3.5L GTDI—INTERMITTENT STUMBLE/MISFIRE ON ACCELERATION FROM HIGHWAY CRUISE IN HUMID OR DAMP CONDITIONS WITH POSSIBLE DTC

TSB 12-10-19

2011-2012 F-150

This article supersedes TSB 12-6-4 to remove the the production fix date, update the Title, Issue Statement, Part List and Service Procedure.

Figure 1 - Article 12-10-19

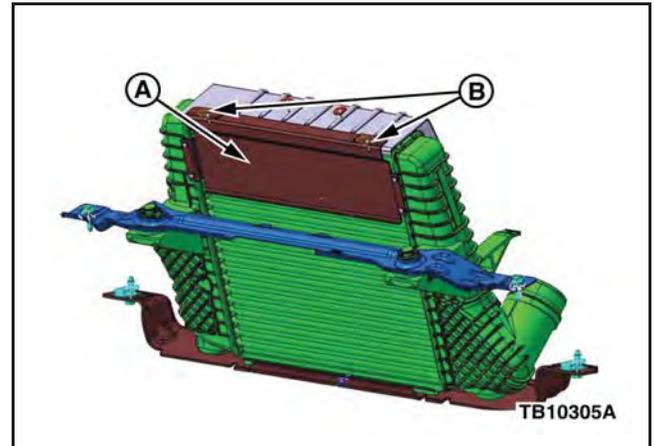
1. Check for DTC P0430. Is DTC P0430 present?
 - a. Yes - Replace the left bank catalytic converter assembly. Refer to Workshop Manual (WSM), Section 309-00. Proceed to Step 2.
 - b. No - Proceed to Step 2.
2. Is the Charge Air Cooler (CAC) equipped with an air deflector plate? (Figure 1A)

- a. Yes - Proceed to Step 5.
 - b. No - Proceed to Step 3.
3. Install a new CAC, new air deflector plate, and original shield using new retaining pushpins. Refer to WSM, Section 303-12. (Figure 1B) Proceed to Step 4.
 4. Reprogram the PCM to the latest calibration using IDS release 79.02A or higher. This new calibration is not included in the 2012.5 DVD. Calibration files may also be obtained at www.motorcraft.com.
 5. Install a new CAC and the original air deflector plate and shield using new retaining pushpins. Refer WSM, Section 303-12.

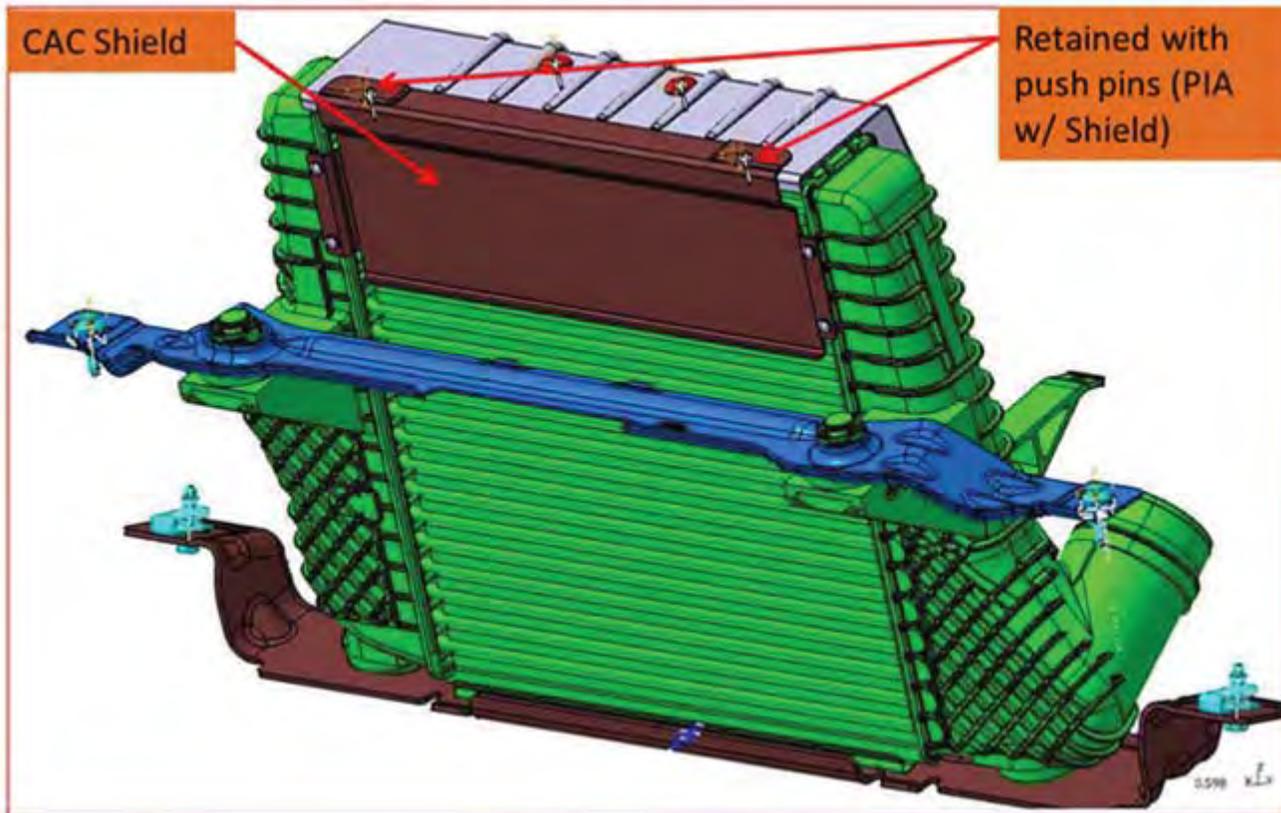
CAC Shield- 5/15/12

Revised CAC- Mid June

Revising TSB 12-2-10 when Shield and R11 Calibrations are confirmed in Production at DTP & KCAP

R11(12MY) Calibration Running Change and R13(11MY) Service Calibration content

P0299 disablement during misfire FMEM

P0234 calibration robustness

Misfire FMEM at low FLI

Surge robustness

Figure 1 - Article 13-3-3

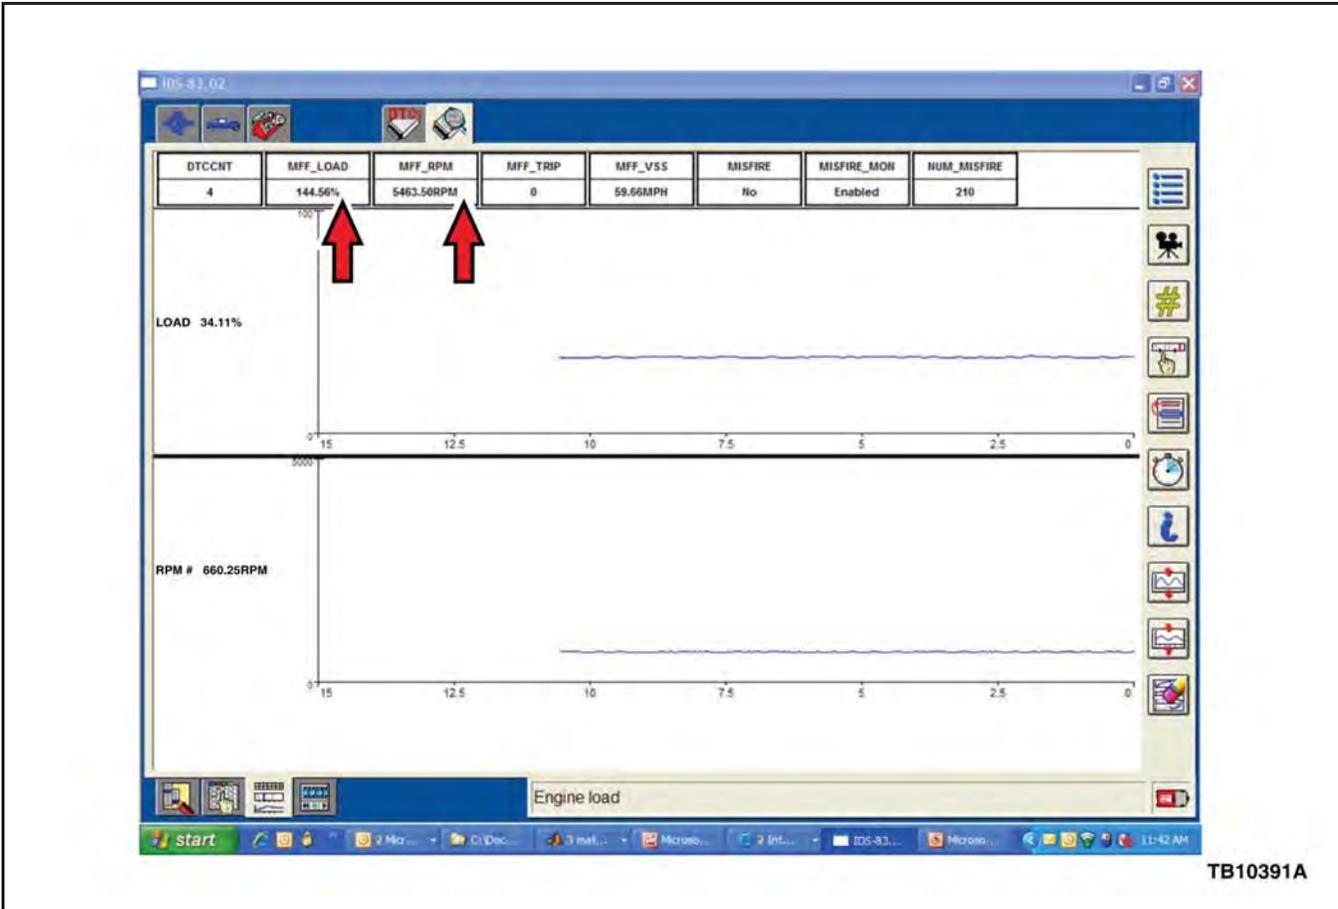
1. Acquire Misfire Freeze Frame Data and DTC¹s with the IDS. Use the following steps with IDS to obtain Misfire Freeze Frame Data.
 - a. Select Toolbox
 - b. Then Data Logger
 - c. Then Modules
 - d. Then PCM
 - e. Next select the following PIDS: MFF_LOAD and MFF_RPM
2. Check for DTC P0430. Is DTC P0430 present?
 - a. Yes - replace the left bank catalytic converter assembly. Refer to Workshop Manual (WSM), Section 309-00. Proceed to Step 3.
 - b. No - Proceed to Step 3.
3. Is the misfire concern only repeatable in humid or damp conditions?
 - a. Yes - proceed to Step 4
 - b. No - this article does not apply. Refer to Powertrain Control Emission Diagnosis (PC/ED) Manual Section 3: Powertrain Symptom Index to inspect such areas as Ignition, Compression, and Injection.
4. Does the Misfire Freeze Frame Data indicate engine speed above 2500 RPM and load 100% or above? (Figure 1)

- a. Yes - proceed to Step 5.
 - b. No - this article does not apply. Refer to PC/ED Manual Section 3: Powertrain Symptom Index to inspect such areas as Ignition, Compression, and Injection.
5. Is the Charge Air Cooler (CAC) equipped with an air deflector plate? (Figure 2A)

Figure 2 - Article 13-3-3

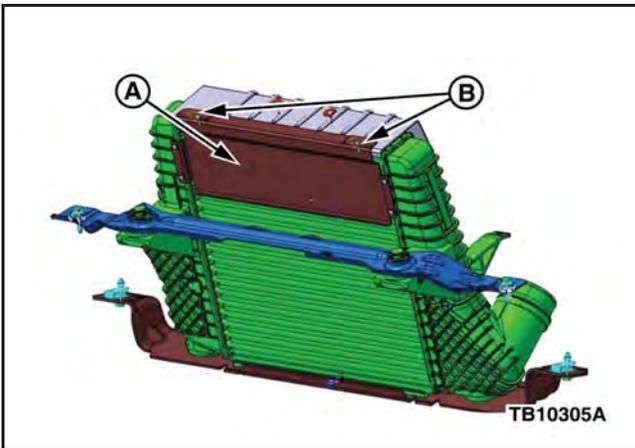
- a. Yes - proceed to Step 8.
 - b. No - proceed to Step 6.
6. Install a new CAC, new air deflector plate, and original shield using new retaining push pins. Refer to WSM, Section 303-12. (Figure 2B) Proceed to Step 7.
 7. Reprogram the PCM to the latest calibration using IDS release 79.02A or higher. This new calibration is not included in the 2012.5 DVD. Calibration files may also be obtained at www.motorcraft.com.
 8. Install a new CAC and the original air deflector plate and shield using new retaining push pins. Refer WSM, Section 303-12.
